# ADA Curb Ramp New Construction Inspection Form (Parallel)

Nw. Glencoe rd

24952.54

Nw. Pacific st.

PARALLEL RAMP (PL)

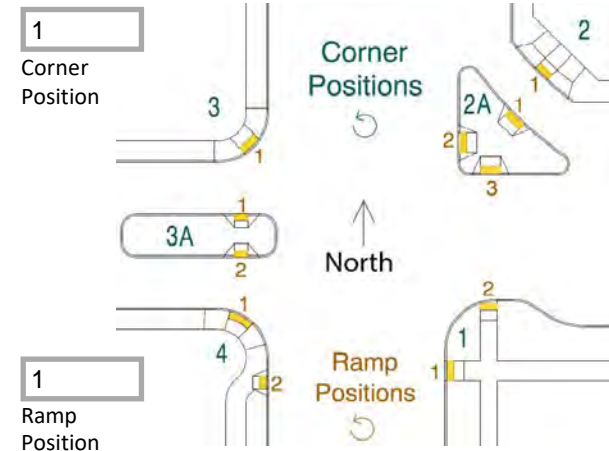
☐  $\leq 2.0\%$  ☐  $> 2.0\%$  ☒

Comments:  
IITD, large comm. box in RR2
